PLANNING NOTES AMENDMENT

Project:	Lower Town House Farm Barn Townhouse Road, Littleborough OL15 9JX		
Title:	Proposed Front Elevation		
Client:	Vernon Wharmby		
Drawn By:	WRS	on	12/08/2024
Original Size:	A2	Project Number:	1017 / 09
Drawing Number:	09 C

Proposed Front Elevation (South)
scale 1:50

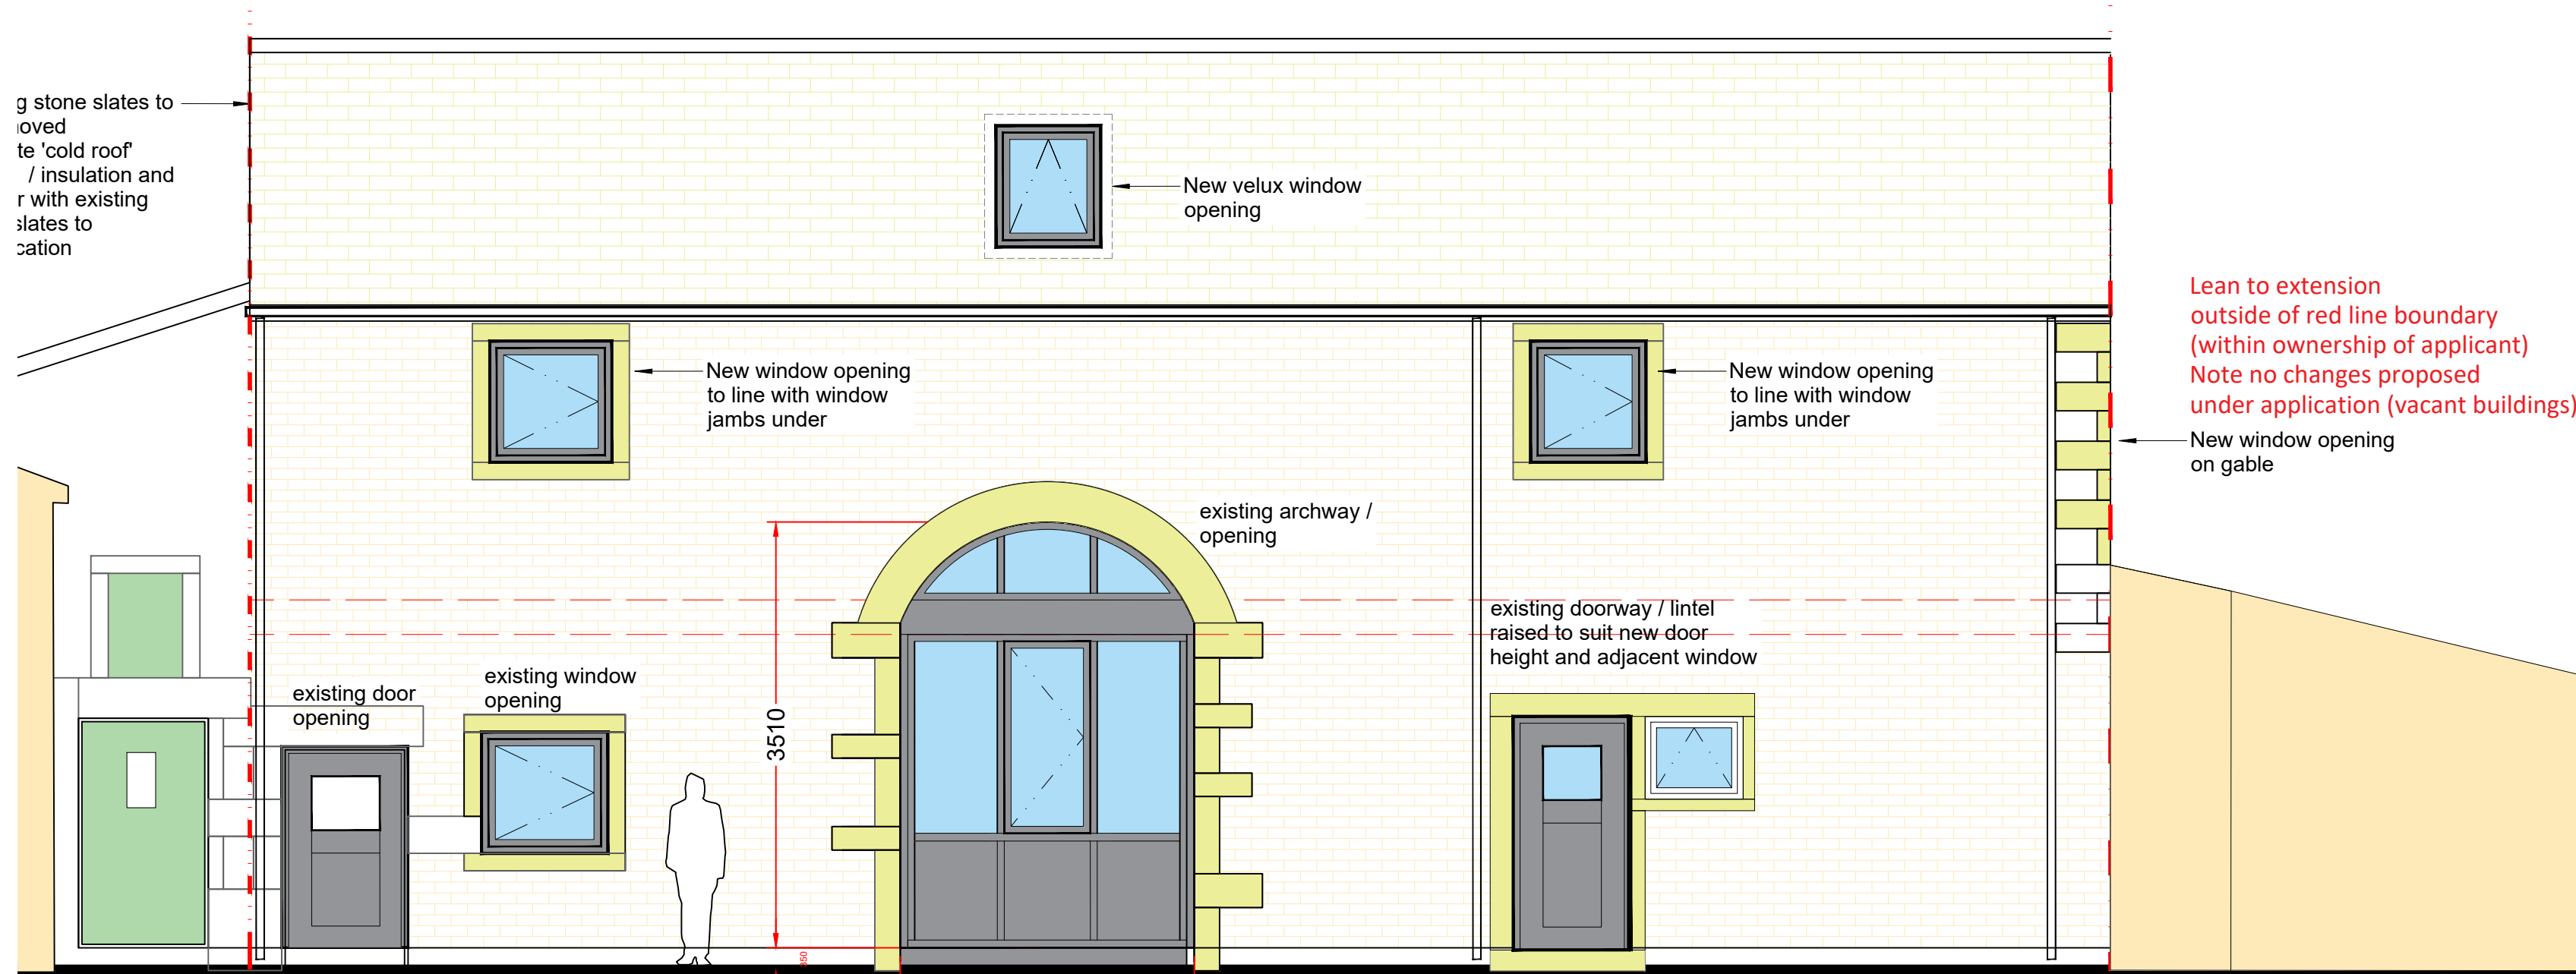
A - 02/11/25 - FFL level raised by 200mm to suit FRA / FFL level = 158.040 and EA requirements
ACO Drainage system incorporated to front & rear building lines - connected into surface water drainage system
